Access Compliance Report Public Rights-of-Way (Curb Ramps)

Main Street: O_NEILL_DR		Cross Street: ROANOKE_DR		Location:	W
ADA ID: RPRK211115113132	Ramp Type: Type 4 - Parallel	Initial Pass/Fail: Fail	Overall Compliance: No	Severity Score:	16

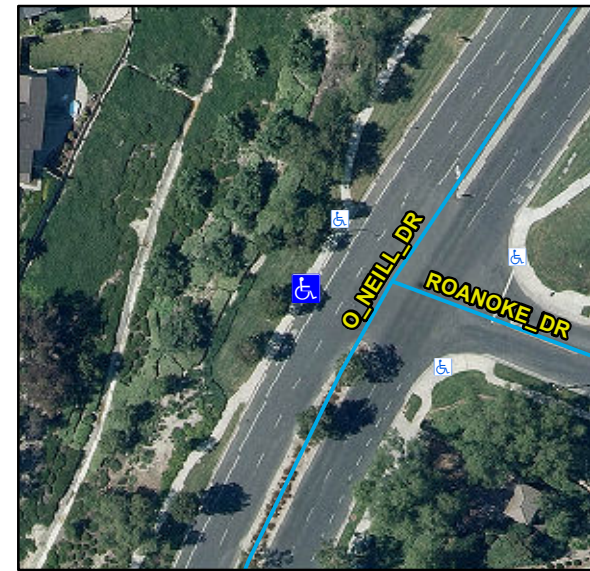
Compliance	Description	Data	Compliance	Description	Data
N/A	Ramp Length LT (in)	121	N/A	Ramp Length RT (in)	123
Yes	Ramp Width LT (in)	53	Yes	Ramp Width RT (in)	53
Yes	Ramp Run Slope LT (%)	2.9	No	Ramp Run Slope RT (%)	9.4
No	Ramp Cross Slope LT (%)	2.3	Yes	Ramp Cross Slope RT (%)	1.3
N/A	Landing Present	N/A	N/A	DWS Provided	N/A
N/A	Landing Length (in)	N/A	N/A	DWS Contrast	N/A
N/A	Landing Width (in)	N/A	N/A	DWS Length (in)	N/A
N/A	Landing Run Slope (%)	N/A	N/A	DWS Full Width	N/A
N/A	Landing Cross Slope (%)	N/A		DWS Offset Type	N/A
N/A	Landing Movement Obstructed?	N/A	N/A	DWS Offset Left (in)	N/A
	Landing Movement Type	N/A	N/A	DWS Offset Right (in)	N/A
N/A	Landing Shared	N/A			
N/A	Clear Space	N/A			
N/A	Clear Space To Crosswalk (in)	N/A			
N/A	Marked Crosswalk 1	No	N/A	Marked Crosswalk 2	N/A
	Crossing 1 Direction	SE		Crossing 2 Direction	N/A
	Marked Crosswalk 1 Width (in)	N/A		Marked Crosswalk 2 Width (in)	N/A

N/A	Ramp Inside Crosswalk 1	N/A	N/A	Ramp Inside Crosswalk 2	N/A
	Crossing 1 Slope (%)	2		Crossing 2 Slope (%)	N/A
	Crossing 1 Cross Slope (%)	4.4		Crossing 2 Cross Slope (%)	N/A
N/A	Gutter Ponding	N/A	N/A	Curb Slope	12.1
Yes	Gutter Lip Height (in)	0		Road Run Slope (%)	N/A
N/A	Gutter Run Slope (%)	N/A		Road Cross Slope (%)	N/A
N/A	Gutter Cross Slope (%)	N/A	No	Perpendicular Joint Present	No
Yes	Overall Surface Condition	Acceptable			
	Cross Gutter Present?	No		Spandrel Present?	No
	Replace Cross Gutter?	N/A		Replace Spandrel?	N/A

Remove & Replace Entire Ramp.

R204.3, R304.5.3, R304.3.2, STD 1115
